## STAFF RECOMMENDATION 1500 Fatherland Street April 29, 2017

**Application:** New construction—addition  
**District:** Lockeland Springs-East End Neighborhood Conservation Zoning Overlay  
**Council District:** 06  
**Map and Parcel Number:** 08313041500  
**Applicant:** Dale Brackeen  
**Project Lead:** Melissa Baldock, melissa.baldock@nashville.gov

<p><b>Description of Project:</b> Application is to construct a rear addition that is wider than the historic house. The project also involves altering a portion of the side façade and front dormer.</p> <p><b>Recommendation Summary:</b> Staff recommends approval of the addition with the following conditions</p> <ol style="list-style-type: none"><li>1. Staff approve the roof color; and,</li><li>2. The HVAC shall be located behind the house or on either side, beyond the mid-point of the house; and</li></ol> <p>With these conditions, staff finds that the proposed addition meets Sections II.B. and IV.B. of the Lockeland Springs-East End Neighborhood Conservation Zoning Overlay.</p>	<p><b>Attachments</b> <b>A:</b> Site Plan <b>B:</b> Elevations</p>
--	--

North Elevation

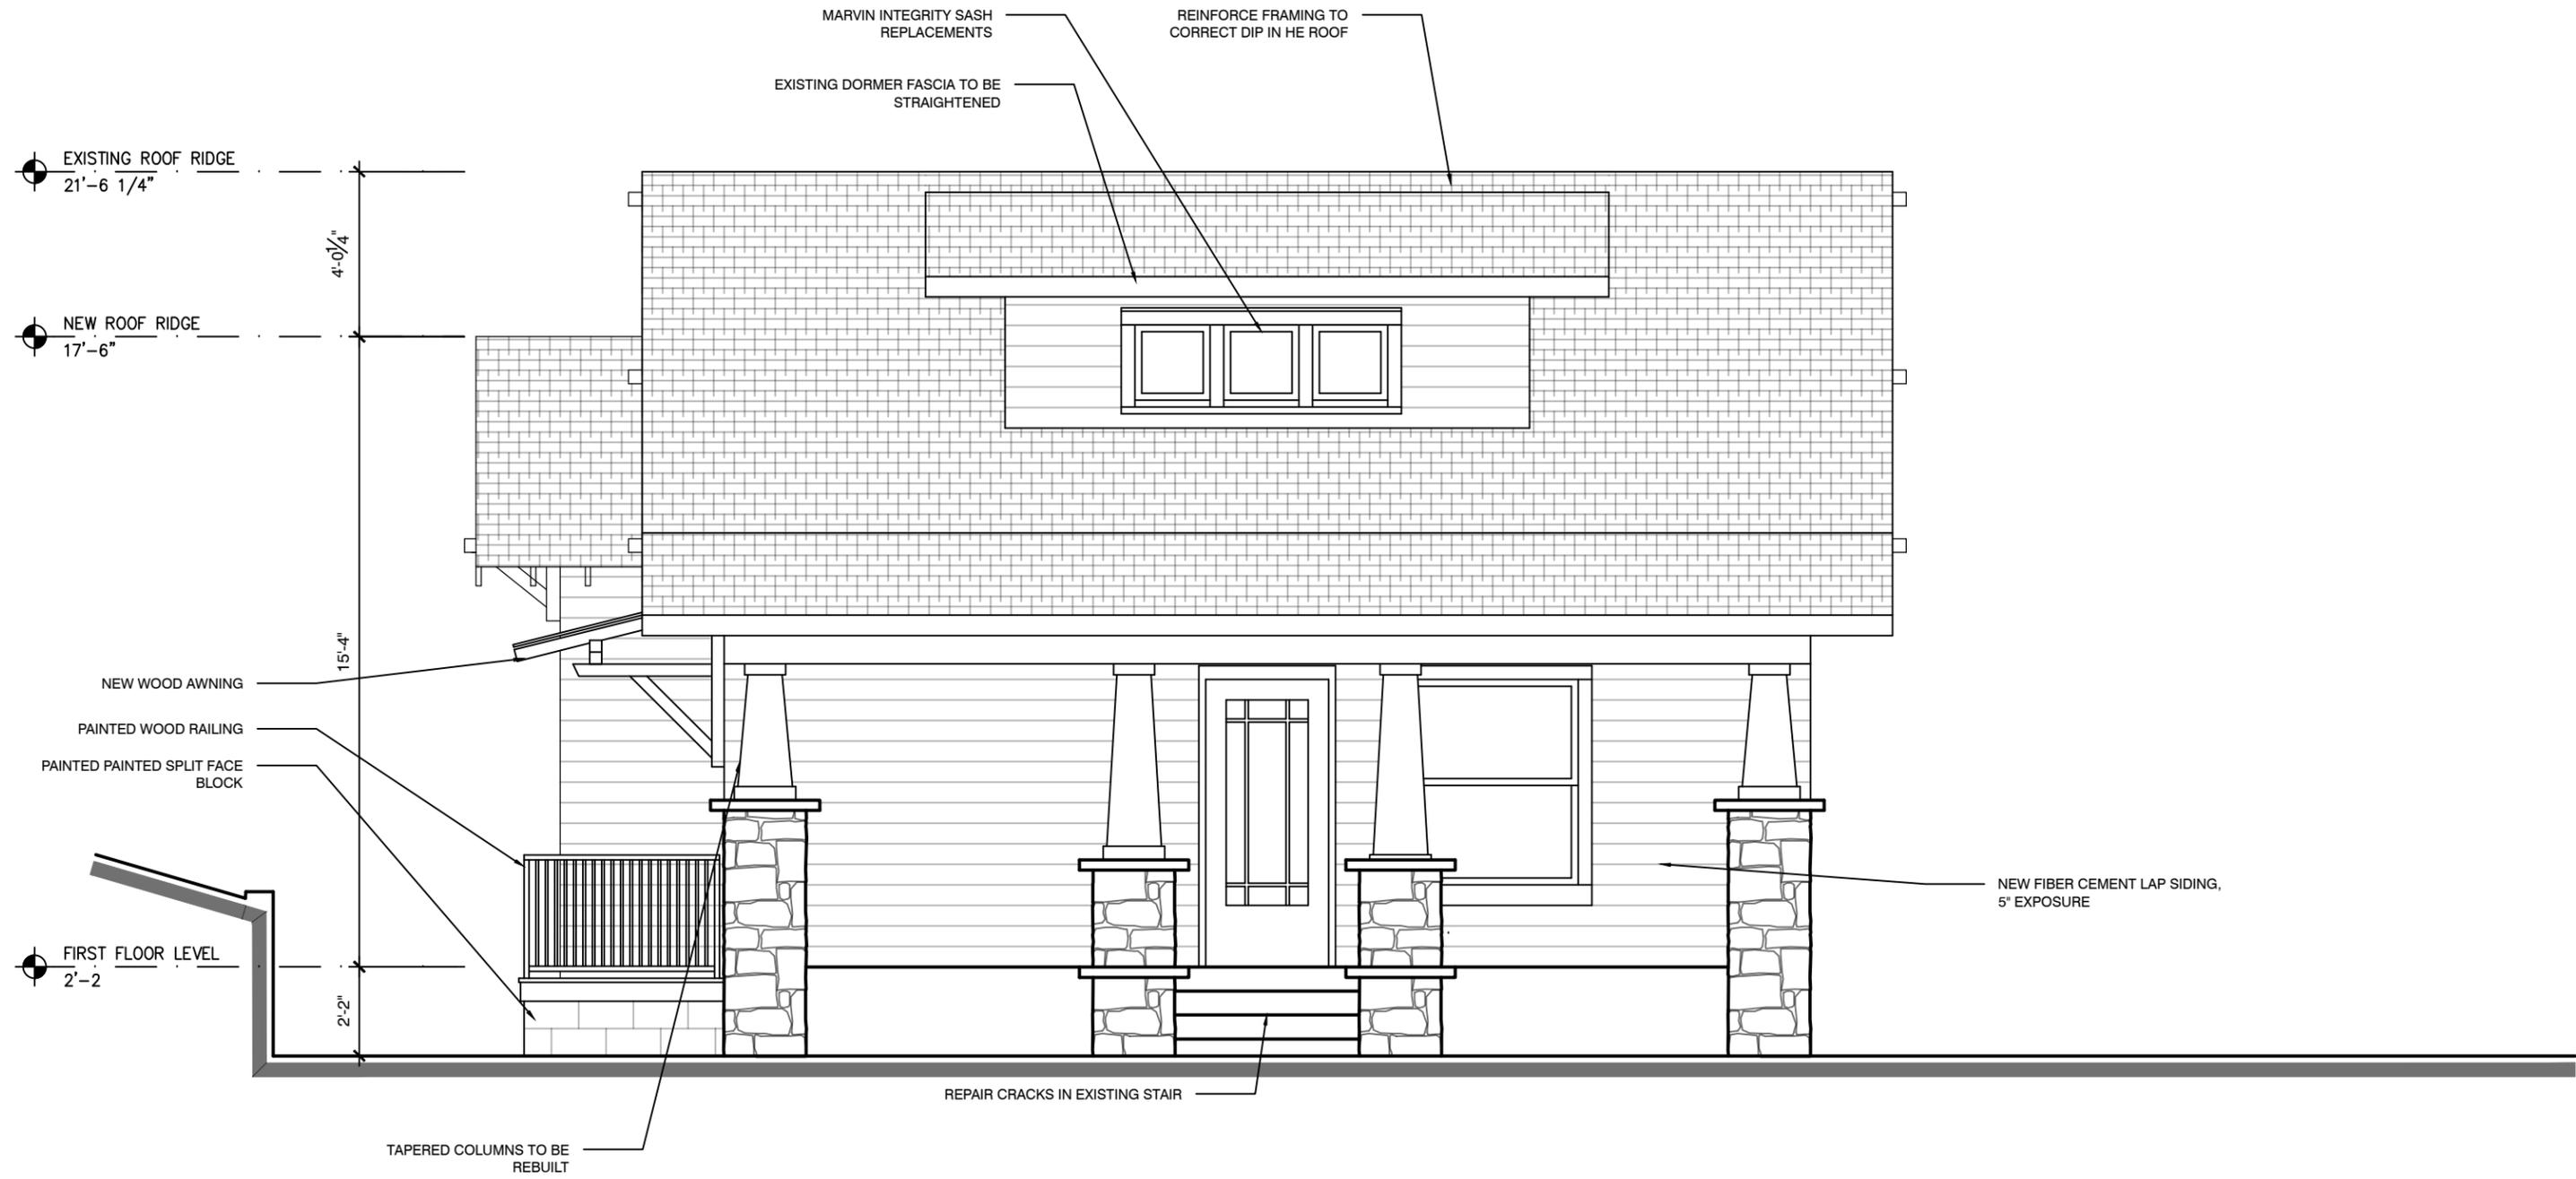
**Partial Demolition:** The applicant intends to alter the window openings on the front dormer, as well as reinforce the framing for the dormer. Staff finds the alteration of the front dormer window openings to be appropriate because the existing window openings

Figure 4.

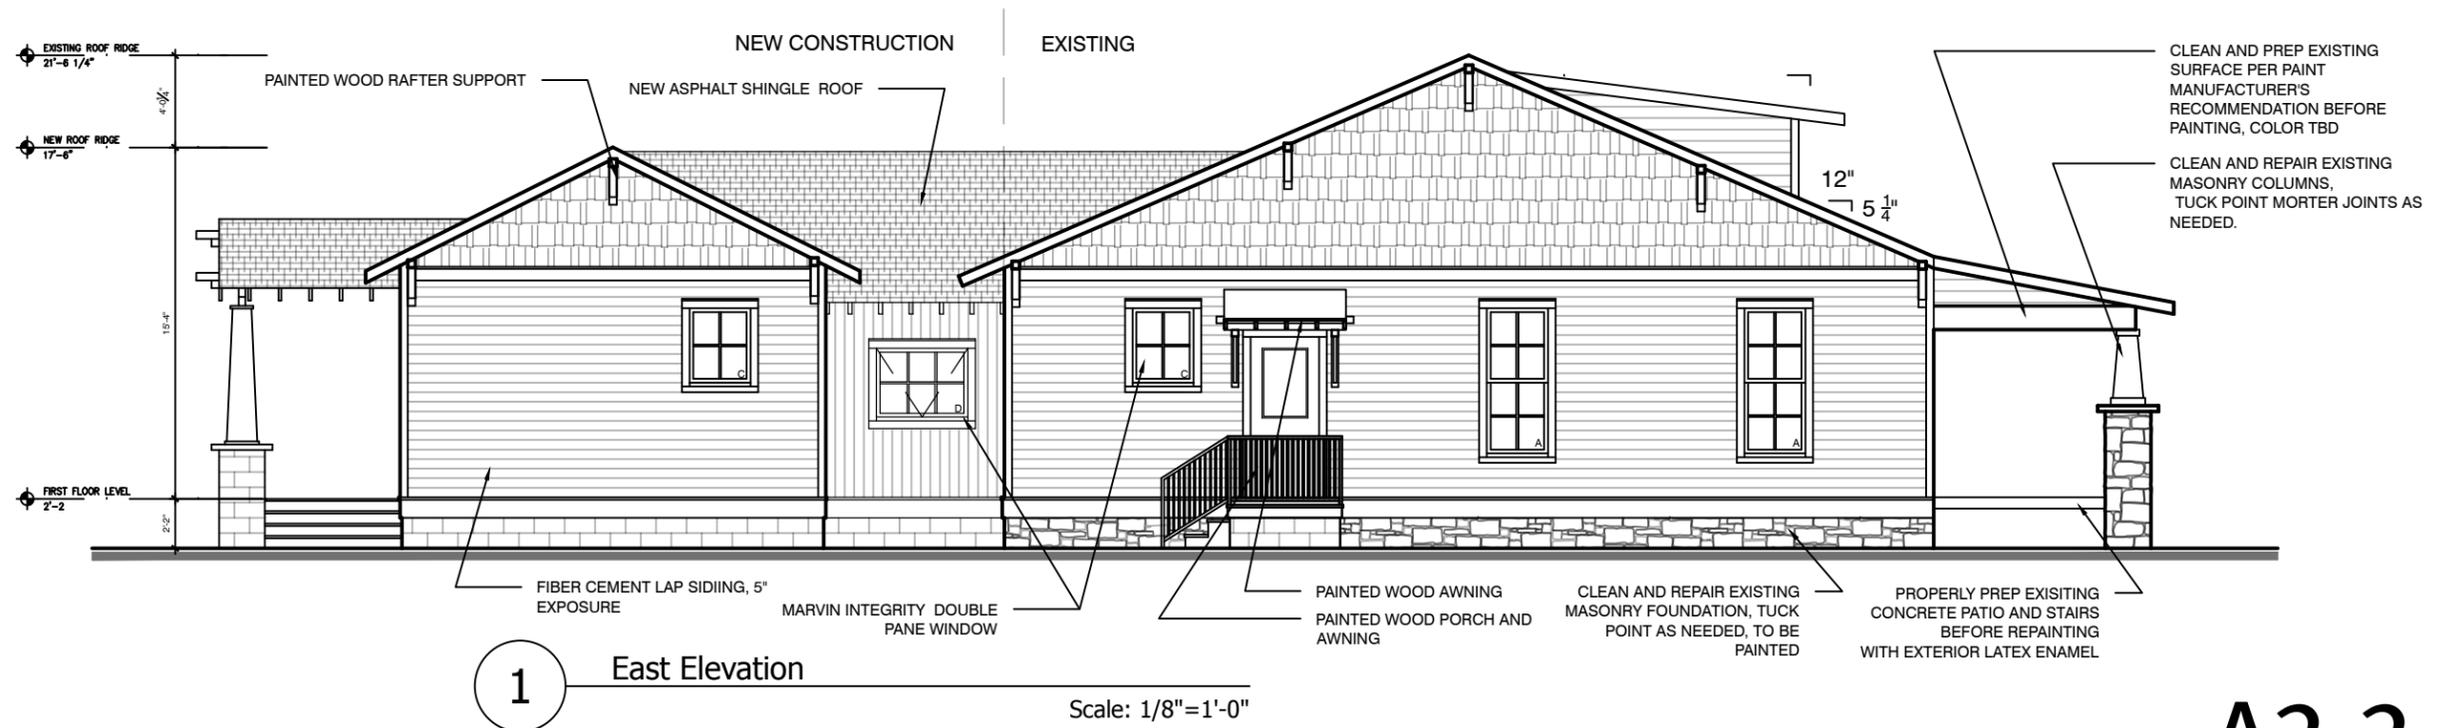
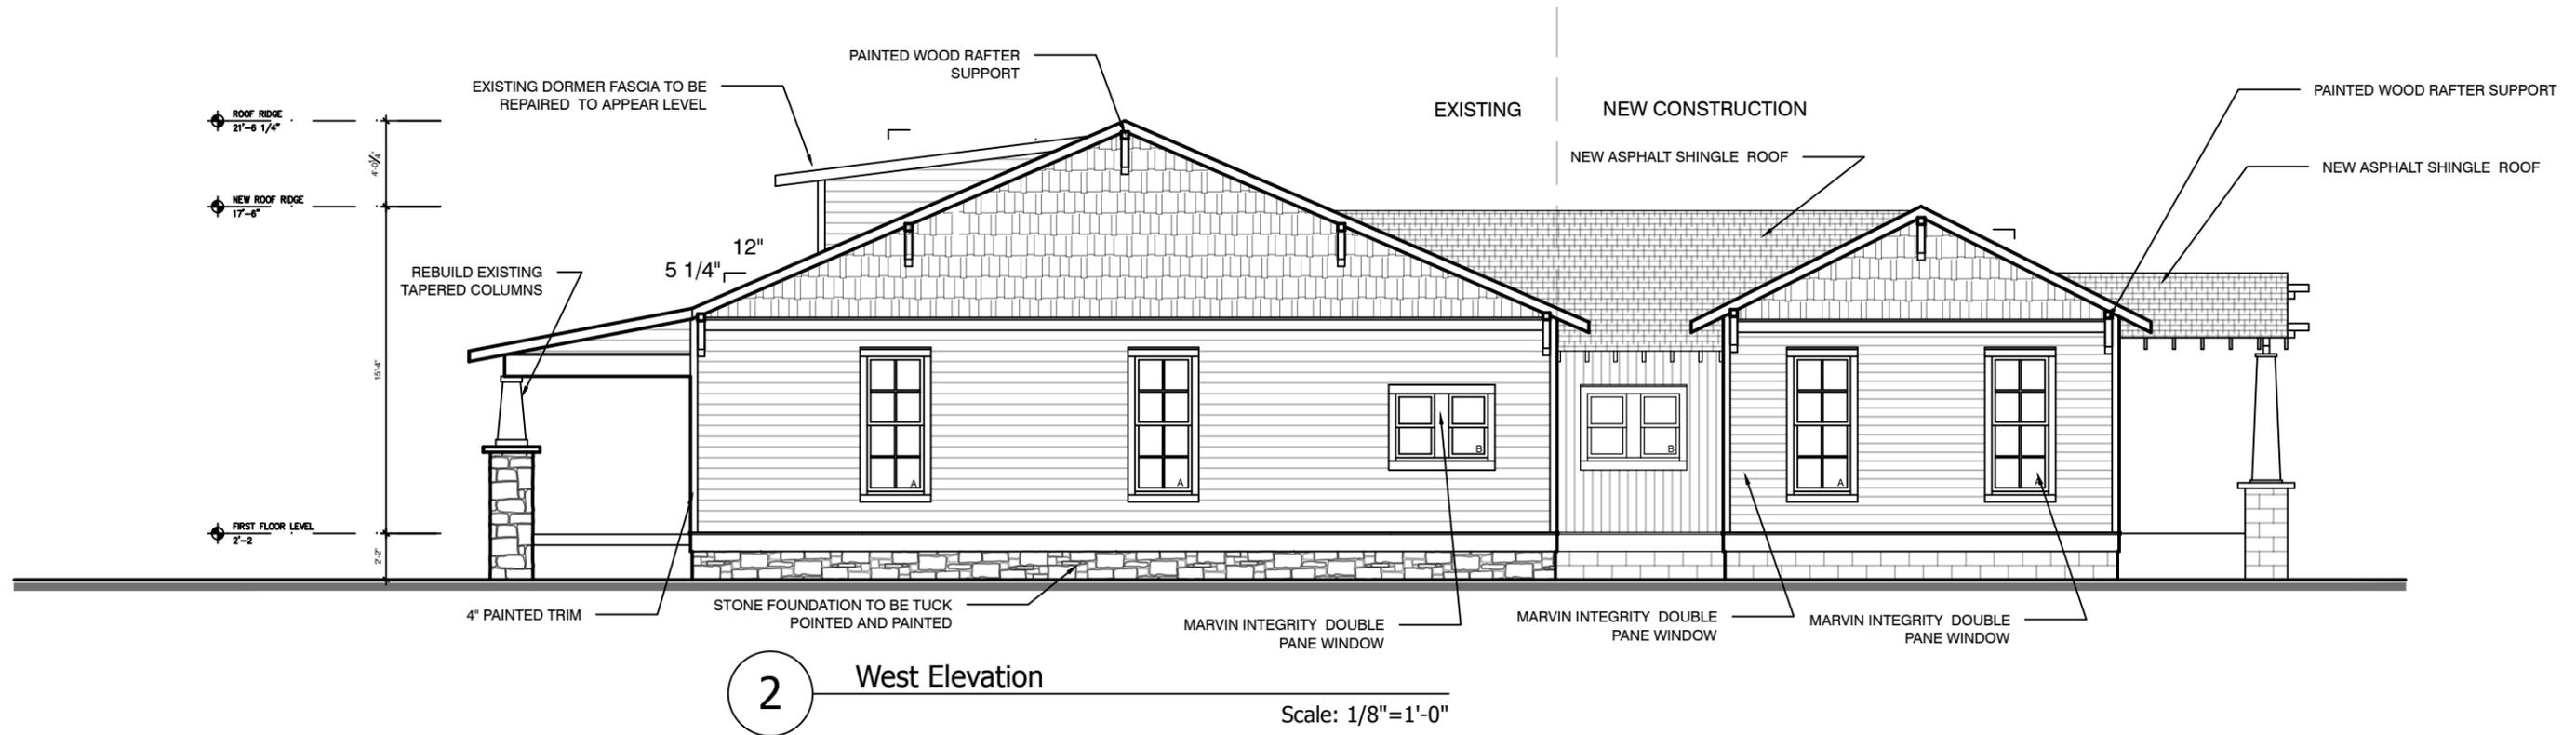
are not original to the house (see Figure 2). The applicant also intends to add a door opening, stair, and door overhang on the left side façade, towards the back (Figure 4). Staff finds the new door opening to be appropriate for several reasons. The window and door configuration on the house have been altered, even on the front façade. The new door opening will be on a side façade, towards the back, and will not greatly affect the historic integrity of the historic house, nor the larger Lockeland Springs neighborhood. The applicant also intends to remove the existing siding and replace it with cement fiber board siding with a five inch (5”) reveal. In conservation zoning overlays like Lockeland Springs the Historic Zoning Commission does not review the replacement of siding if no other significant materials like the roof and windows are to be removed. In this case, most of the other materials will remain, and the existing siding has been altered over time with new window openings.

Staff therefore finds that the proposed partial demolition of the front dormer window openings and the left side façade and the siding replacement meet Section III.B.2 for appropriate demolition and does not meet section III.B.1 for inappropriate demolition.
